RE: Waller Creek District: ADDENDUM to the Waterloo Parkland Design Development Phase Plan

**ADDENDUM to the Waterloo Park  
Design Development Phase Plan**

**Part One: Parkland**

WATERLOO PARKLAND  
Sector 9 Area Breakout

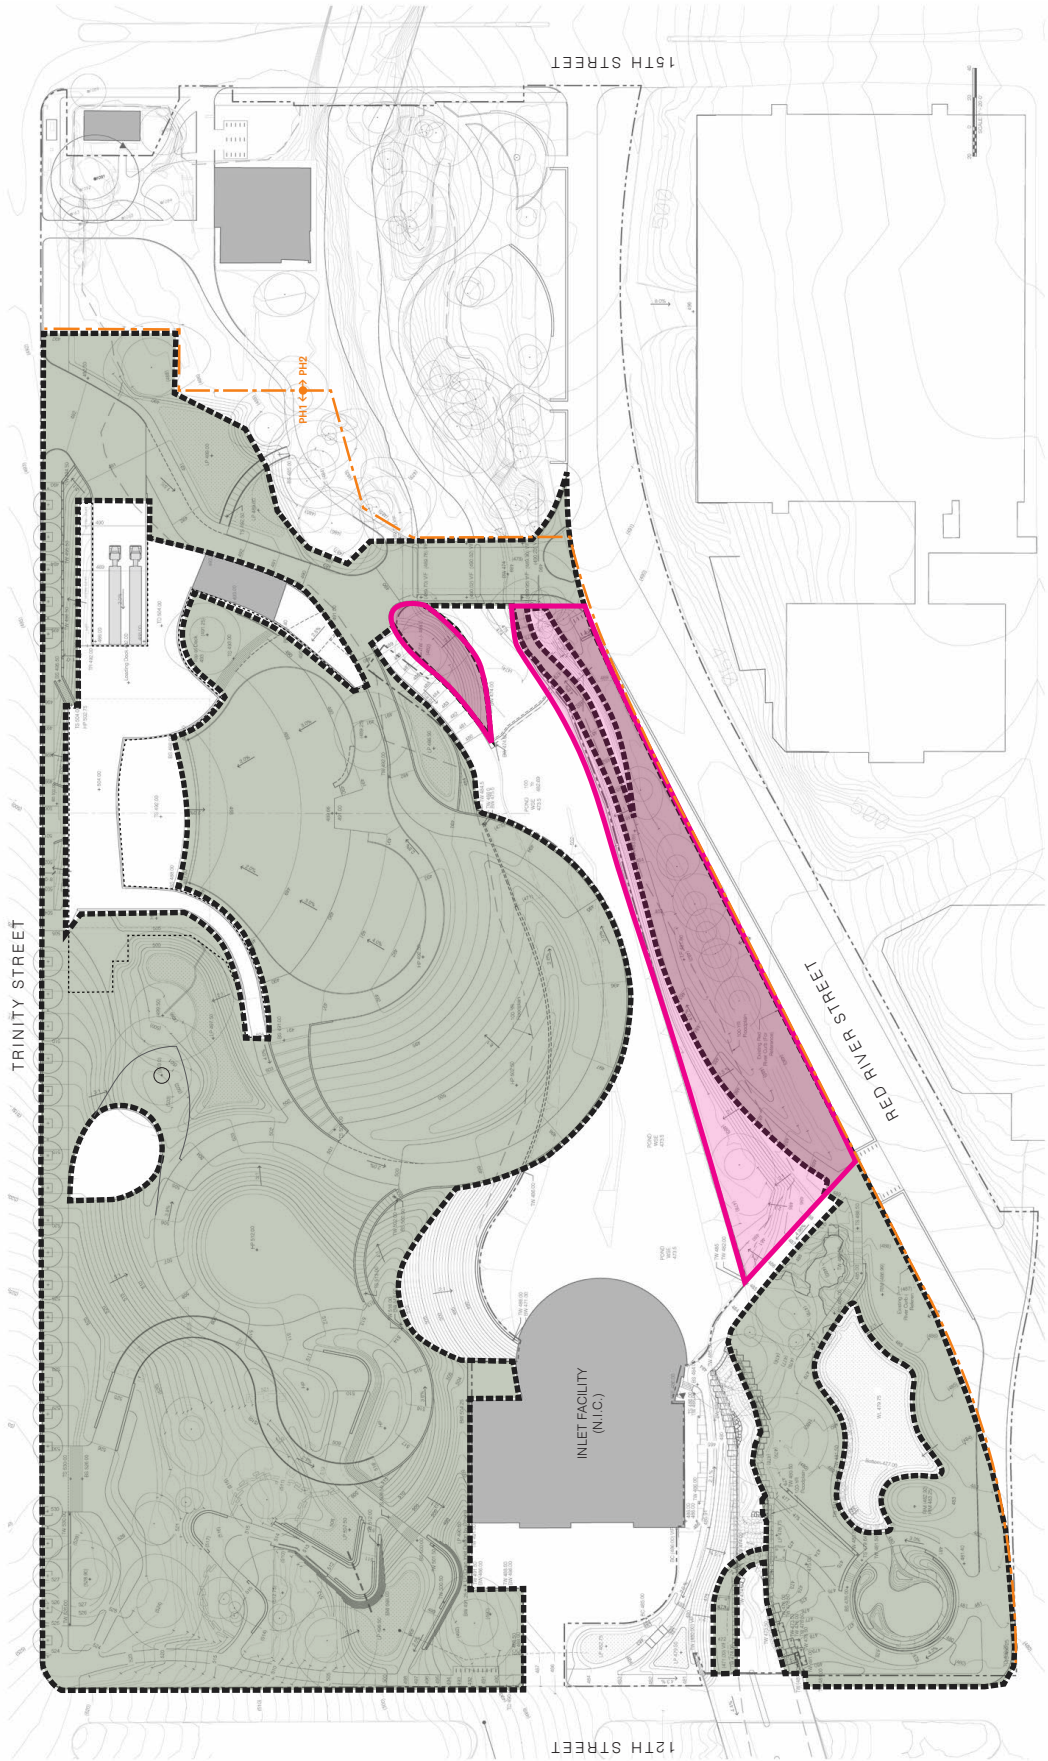
Total Parkland = approximately 314,000 sf  
East Bank Breakout area = approximately 30,500 sf  
East Bank Breakout Area = approximately 10% of Parkland

**WATERLOO PARKLAND**  
**Sector 9 — Consultant Team Scope**

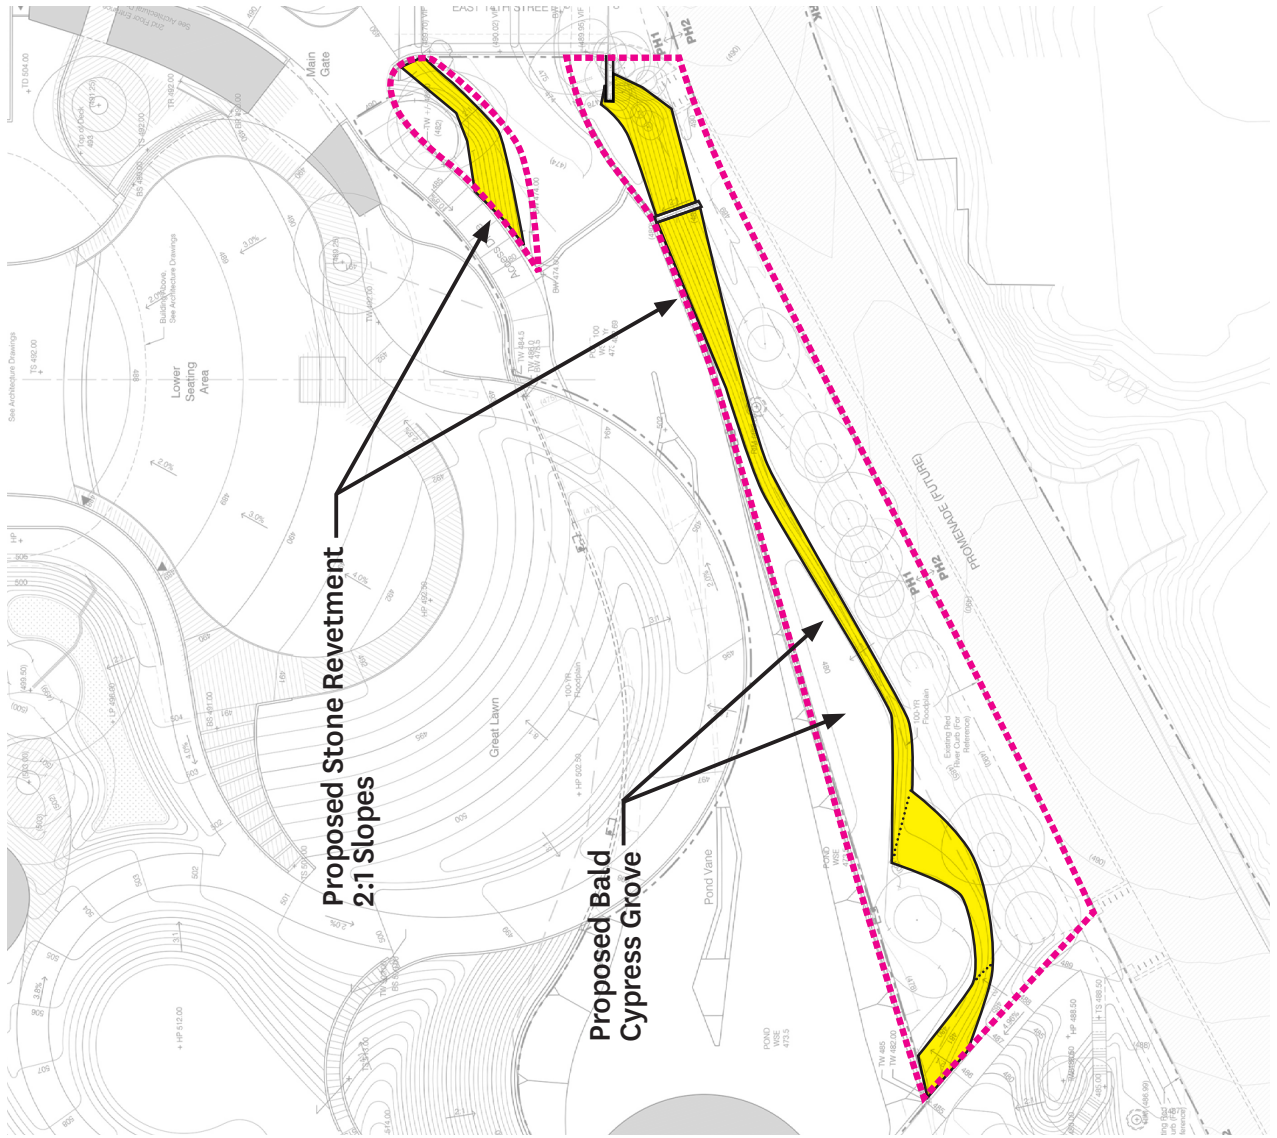
CONSULTANTS WITH FEES TO BE BROKEN OUT  
 10% of Parkland Fees:

1. MWVA
2. Big Red Dog
3. dwg
4. Olsson

CONSULTANTS WITH ADDITIONAL SCOPE:

1. MWVA
  - east bank stone revetment area (previously included in tunnel contract) adds 9,000 SF to Parkland area and requires new concept and redesign
  - additional funding breakout creates additional administrative load
2. Terracon
  - geotechnical slope stabilization
  - stone revetment engineering
  - review of existing wall plans and configurations
  - geotechnical design of slope stabilization options
  - geotechnical design of stone revetment options
  - review/design of interactions/connections between existing walls/slopes and proposed slopes/revetments

CONSULTANTS NOT INCLUDED IN THIS PROPOSAL:  
 Tillet, EEA, AEC, Altura, James Pole, LimnoTech,  
 Wayfinding
